# ST. PETERSBURG COLLEGE

## EPI-TECH BUILDING

### ADDENDUM NO. 1

MATRIX PROJECT NO. 17-0720

M1.1

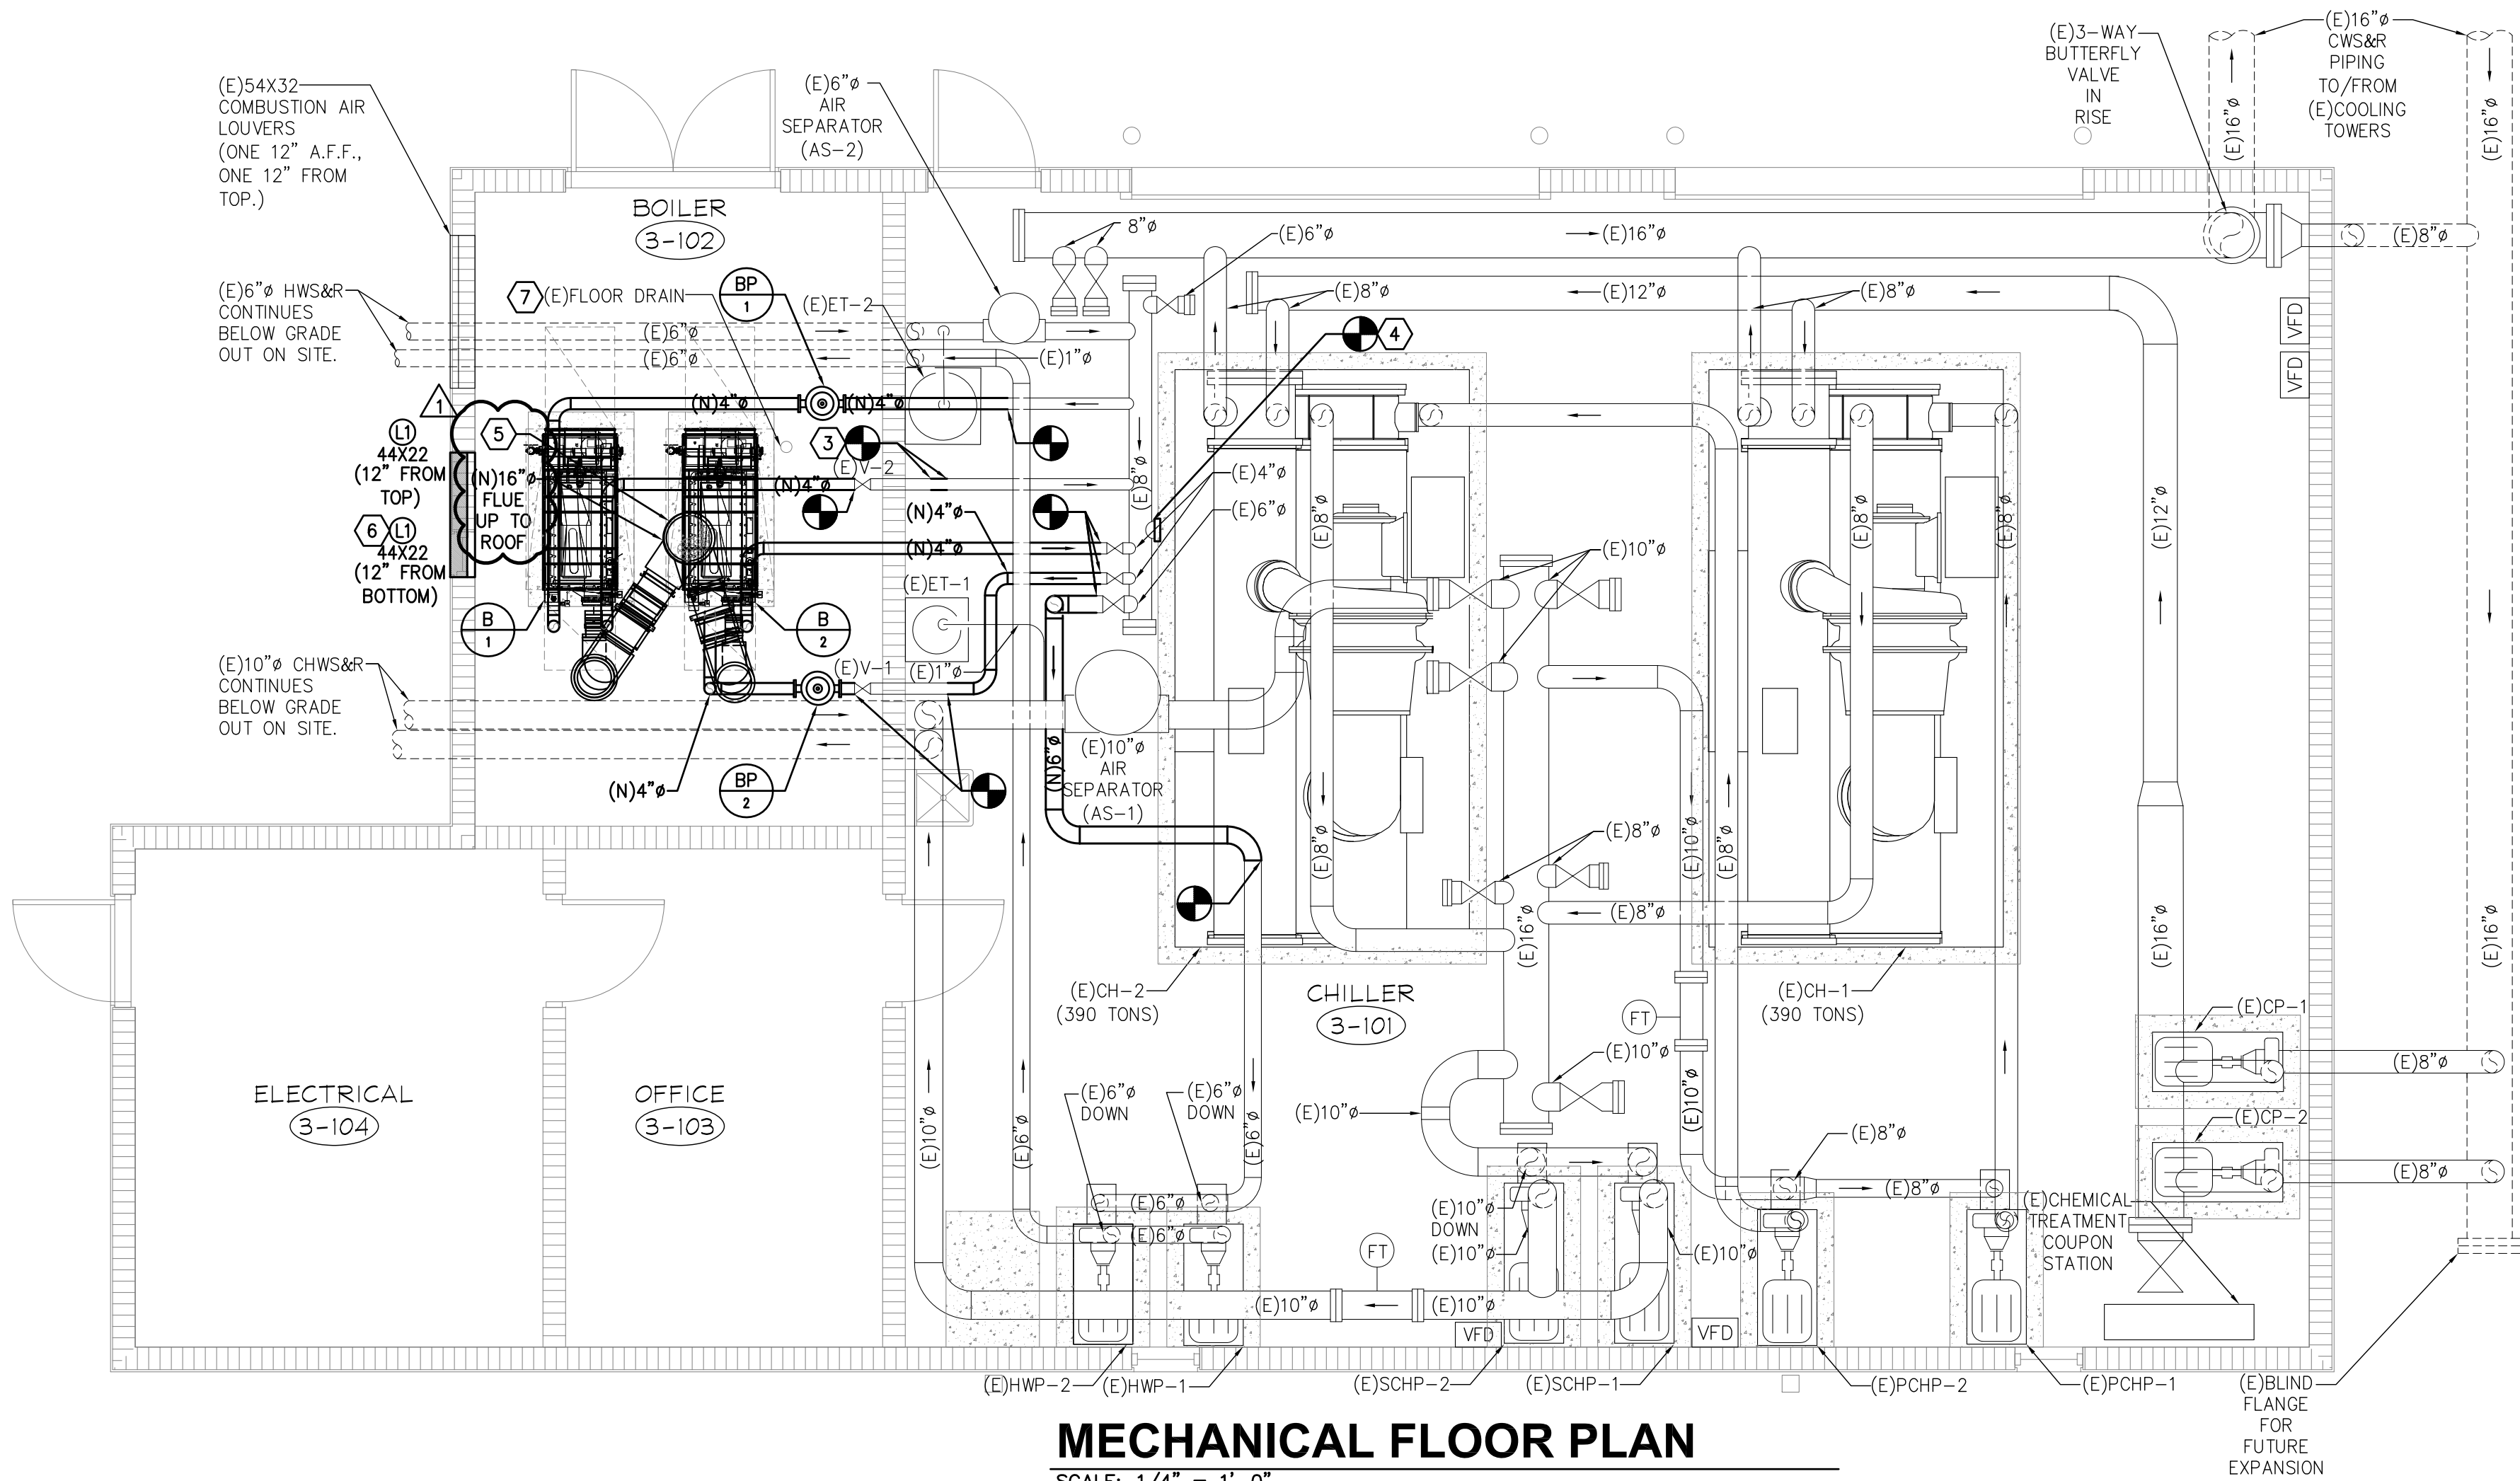
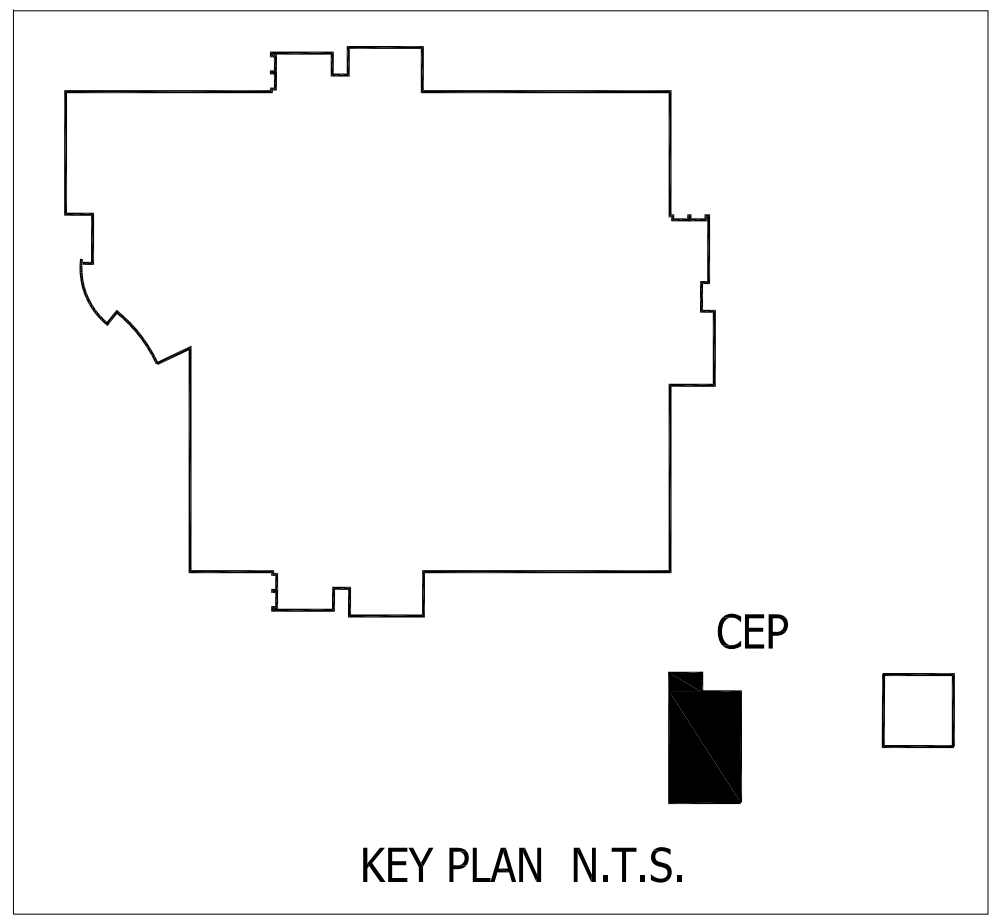
- Item 1. Drawing M1.1, Mechanical Floor Plans.
- ☐ MODIFIED the boiler flue demo and new scope of work to include all new Category IV venting.
  - ☐ CLARIFIED the (E)BP-1 shall be turned over to the Owner (should Bid Alternate #1 not be accepted).

BOILER FLUE DETAIL

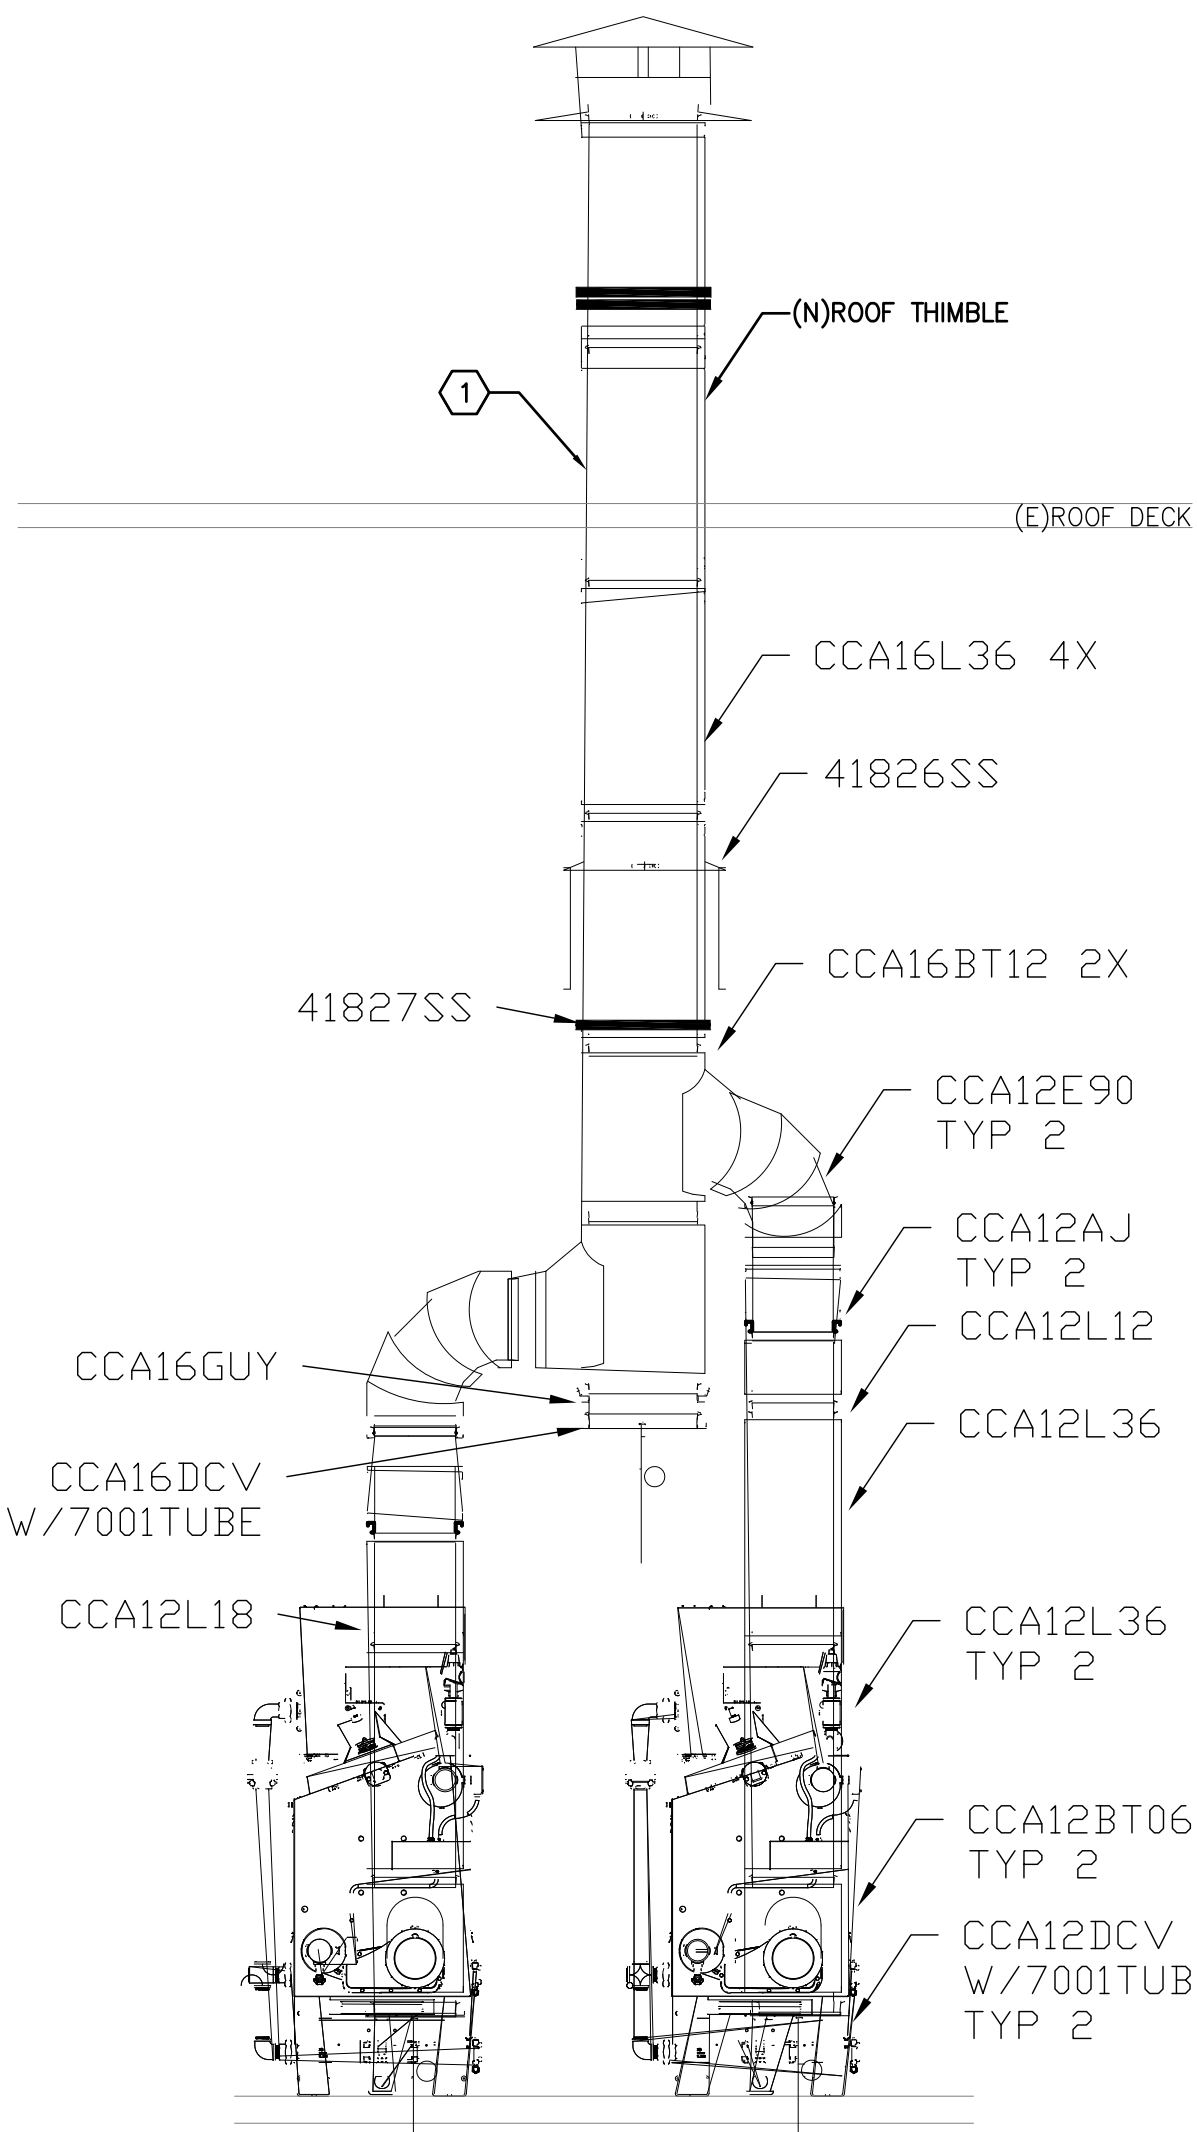
Item 2. Drawing M2.1, Mechanical Details

- ☐ MODIFIED the Boiler Flue Detail include all new Category IV venting.

- (1) NEW CAT IV BOILER FLUE SHALL EXTEND A MINIMUM OF 2'-0" ABOVE THE EXTERIOR WALL OF THE ADJACENT CHILLER ROOM. CONTRACTOR SHALL PROVIDE SIGNED AND SEALED DESIGN DOCUMENTS FOR THE SUPPORT OF FLUE VENT ON ROOF.
